Addendum/Addenda

No./N° 2

Design-build a semi-detached research house for the Candian Centre for Housing Technology

2016 March 16

1
A01
PROPOSED UTILITY CONCRETE SLAB & CURB 8440mm X 8440mm (27'8.25" X 27'8.25")
SCALE = 1:50

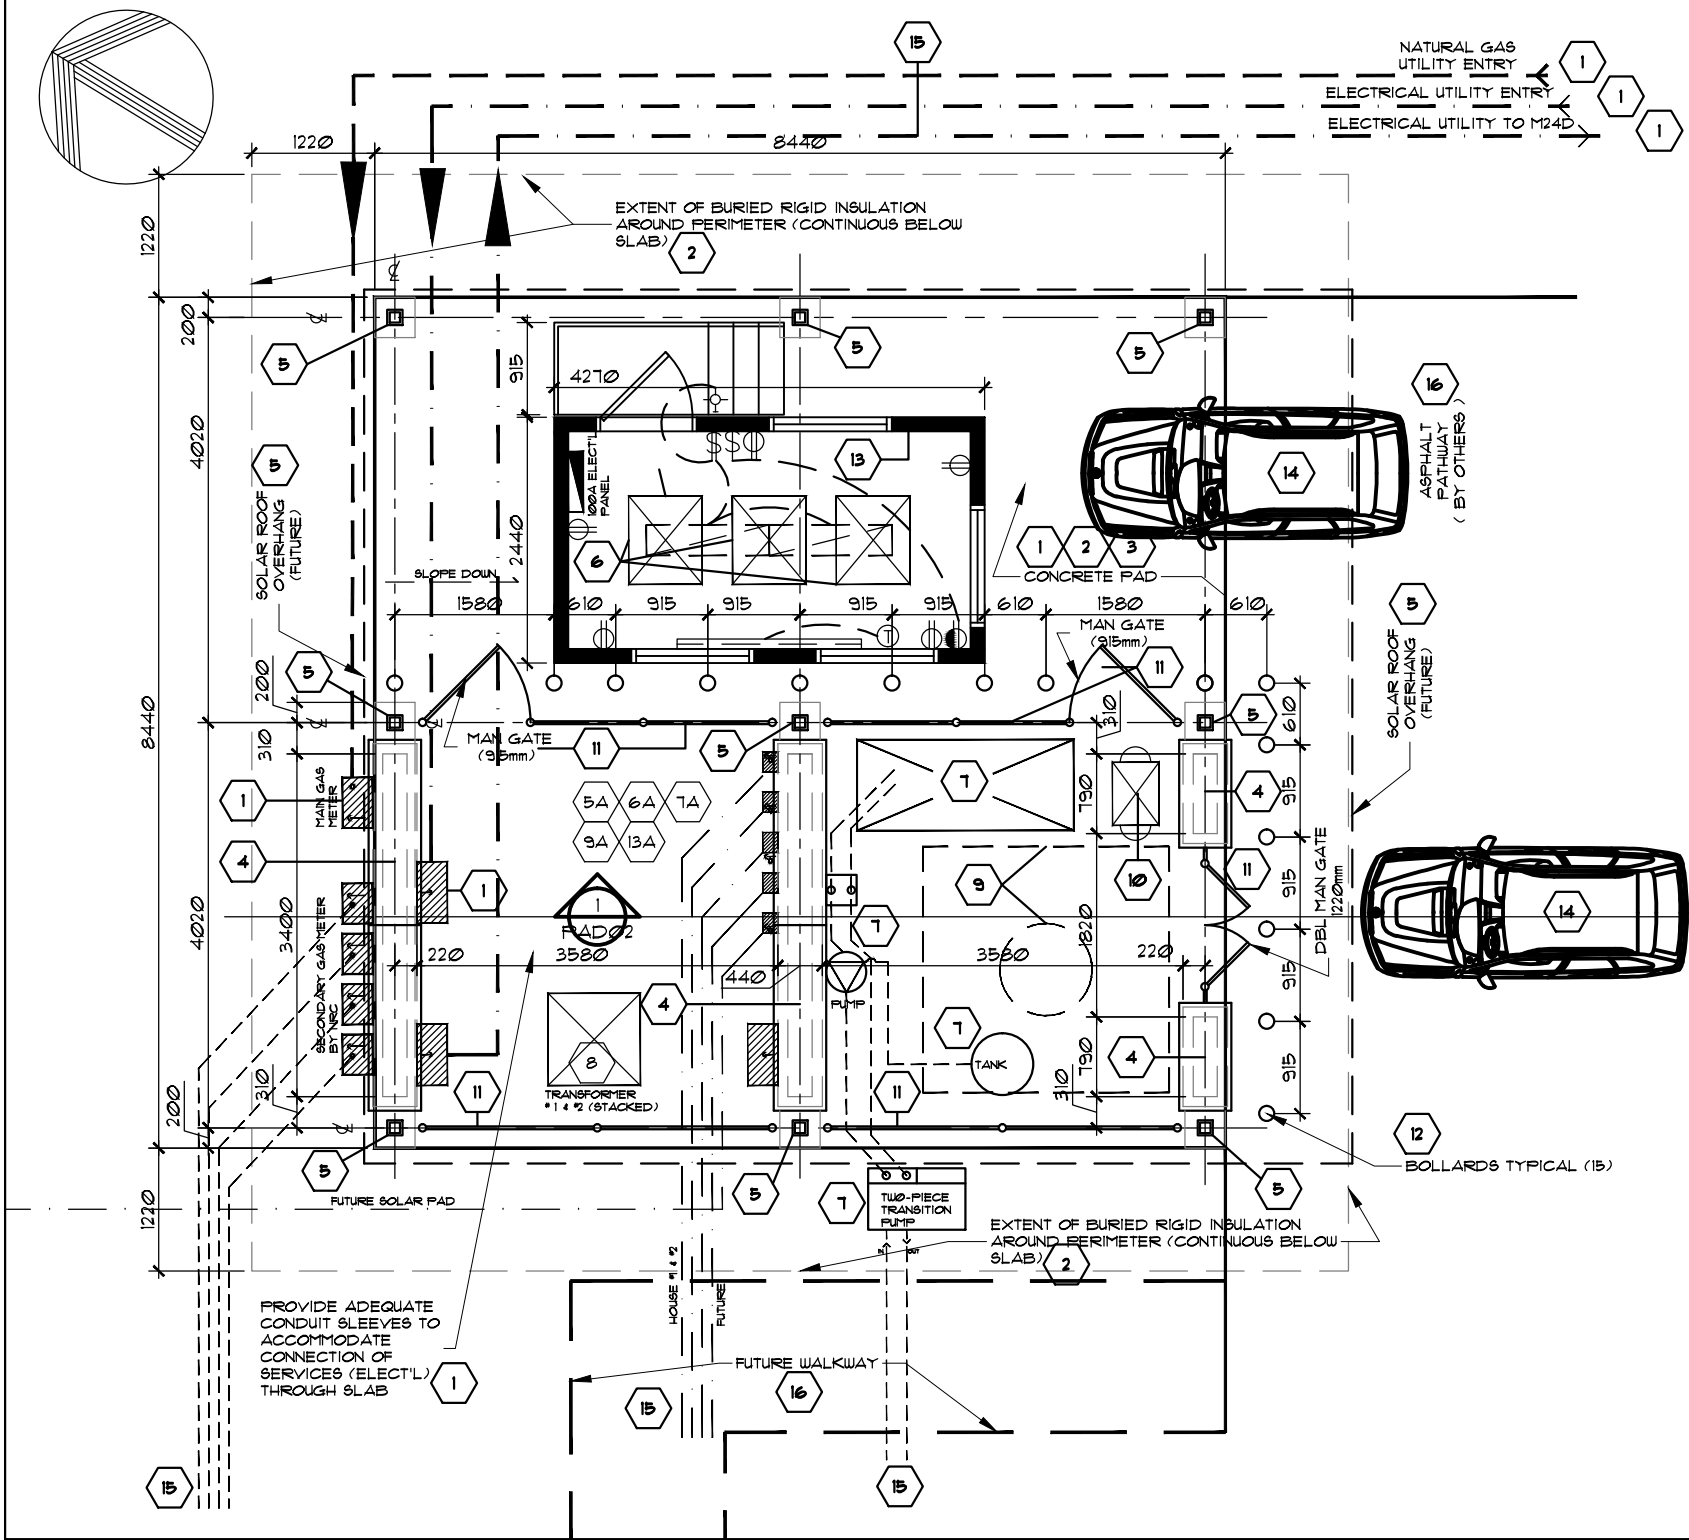
1. A civil engineering firm has been contracted by NRC to provide a site services plan and a site grading plan. These will be provided to the builder.
2. Concept design drawings for the Power Pad are attached to this addendum. Verification that the concept design meets the objective of the project will be the responsibility of the proponent. Any alterations suggested by the successful proponent will be considered. The proponent shall use the concept design as the basis for preparing the Power Pad construction drawings, which shall include the appropriate structural specifications and details. The RFP technical scoring criteria is modified to suite, according to the revised scoring table attached to this addendum.
